| ROADWAY PLAN                                                         |                                                    |
| INTERSTATE ROUTE H-1 RESURFACING                                     |                                                    |
| Miller Pedestrian Overpass to Kapiolani Interchange                  |                                                    |
| Federal-Aid Project No. NH-HI-1(279)                                 |                                                    |

SHEET No. R12 OF 41 SHEETS

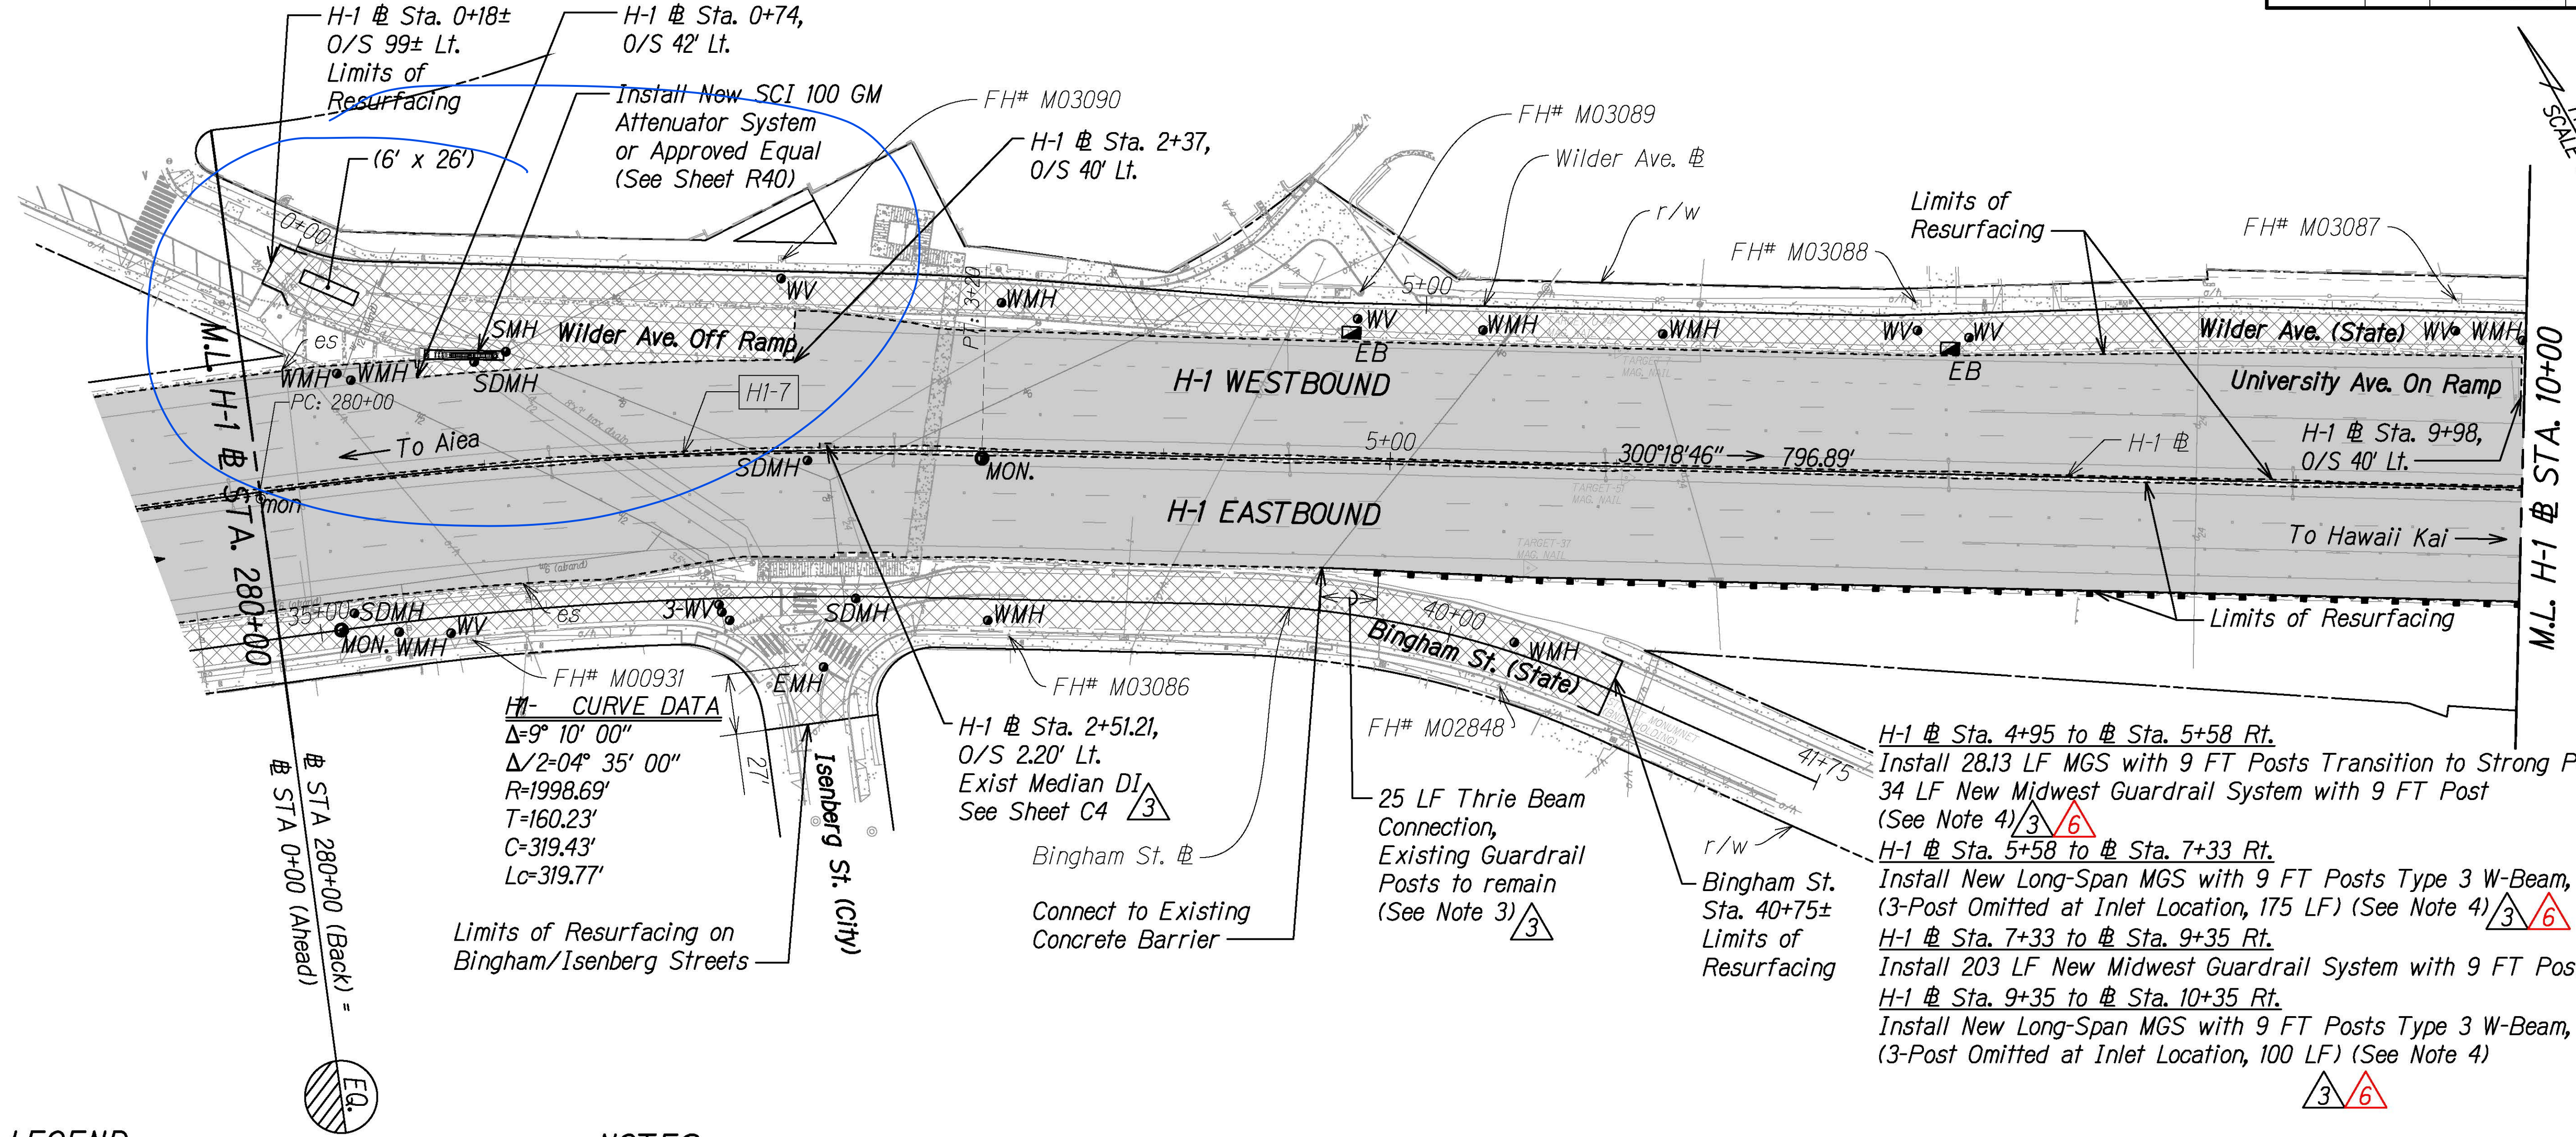
| 7/21/21 |  | Revised Guardrails                                                     |
| 7/9/21  |  | BWS Tracings and<br>Revised Guardrails<br>Added Exist. Median DI label |

| SHEET No. R14 OF 41 SHEETS                                           |                   |

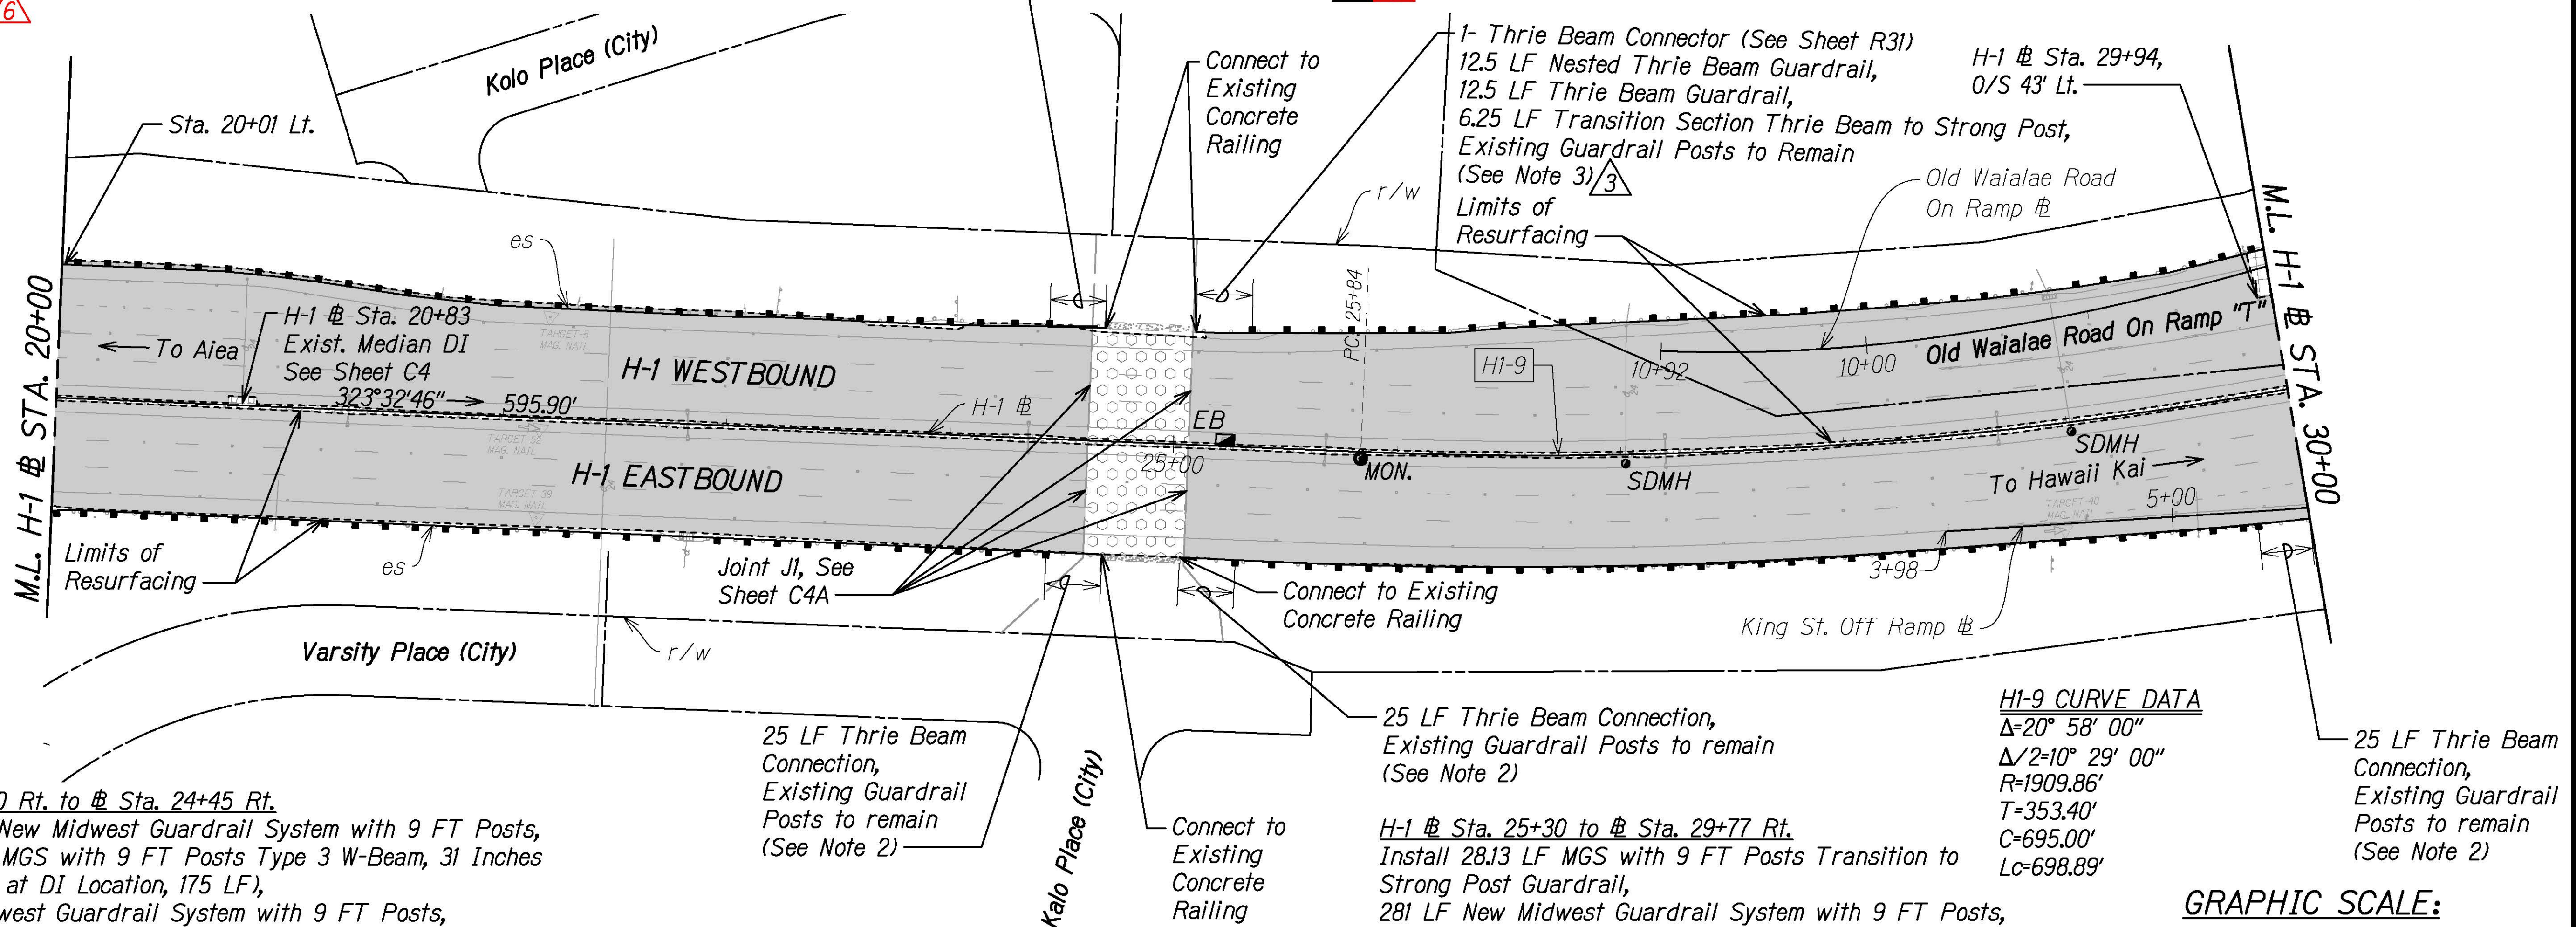
| 7/21/21 | <span style="border: 1px solid black; padding: 0 2px;">6</span> Revised Guardrails                                       |
| 7/9/21  | <span style="border: 1px solid black; padding: 0 2px;">3</span> BWS Tracings, Revised Guardrails, Pav't Section & Limits |

SHEET No. R16 OF 41 SHEETS

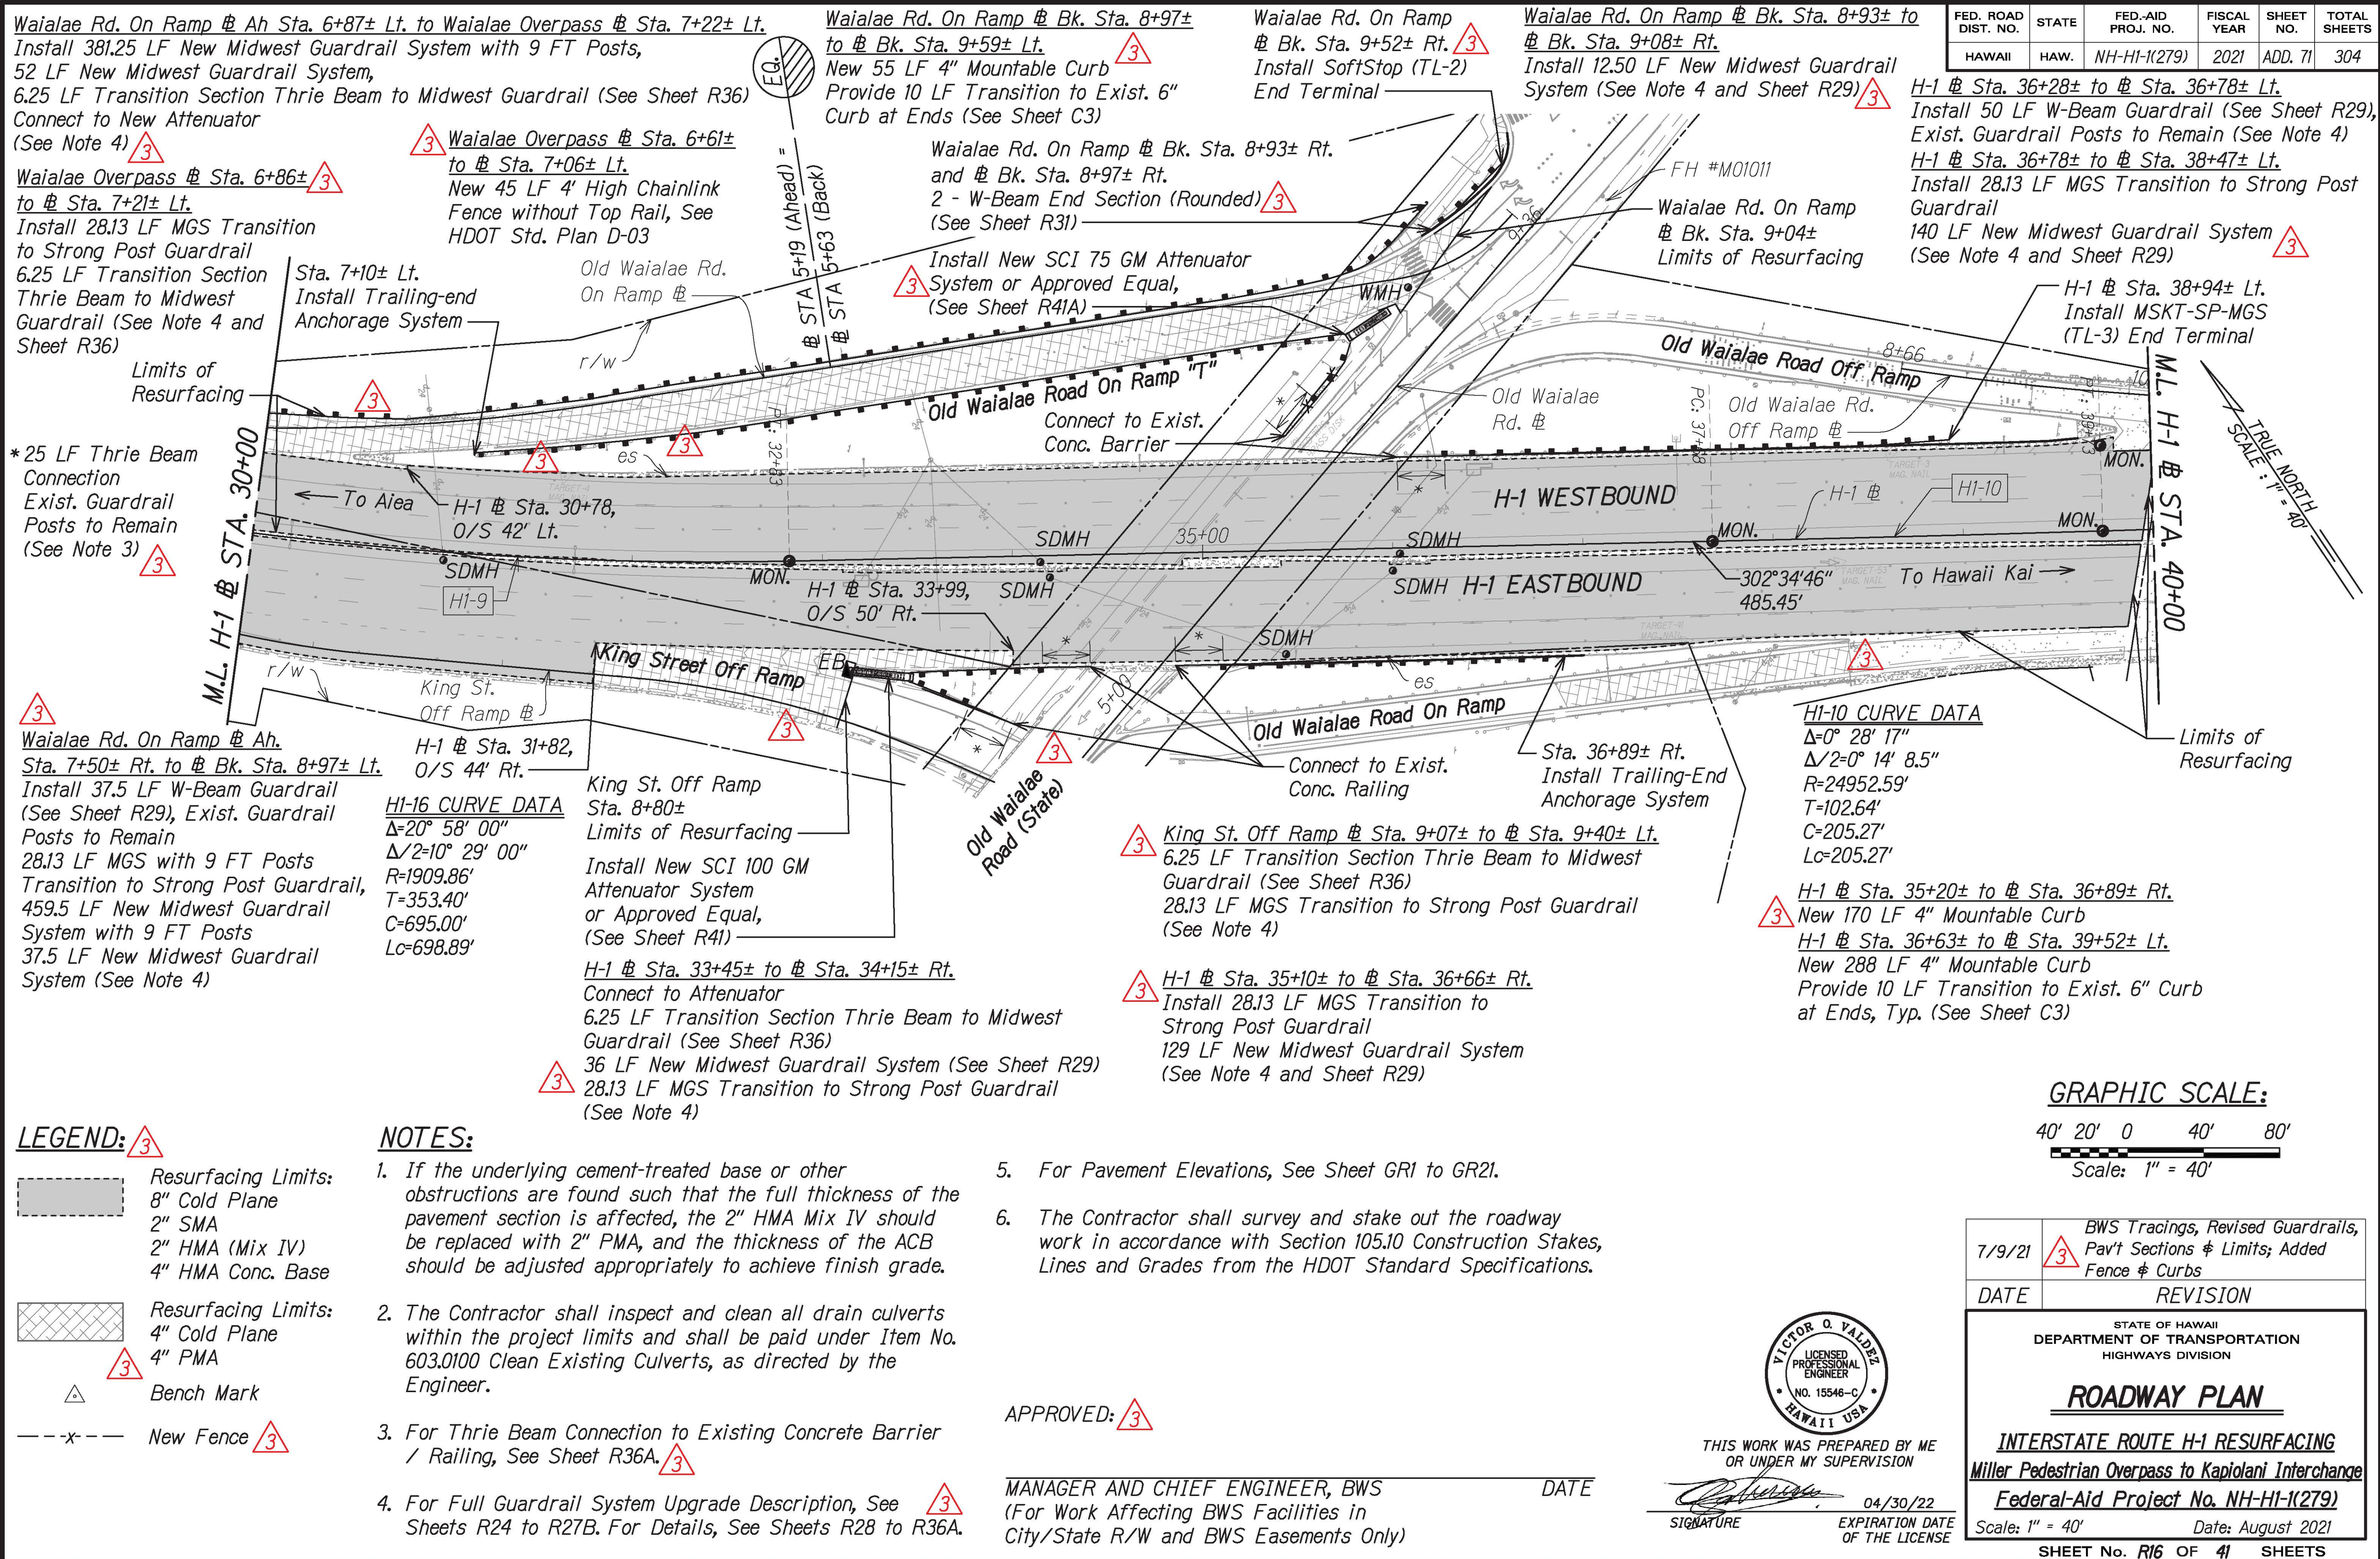
7/9/21 3 BWS Tracings, Revised Guardrails, Pav't Sections & Limits; Added Fence & Curbs
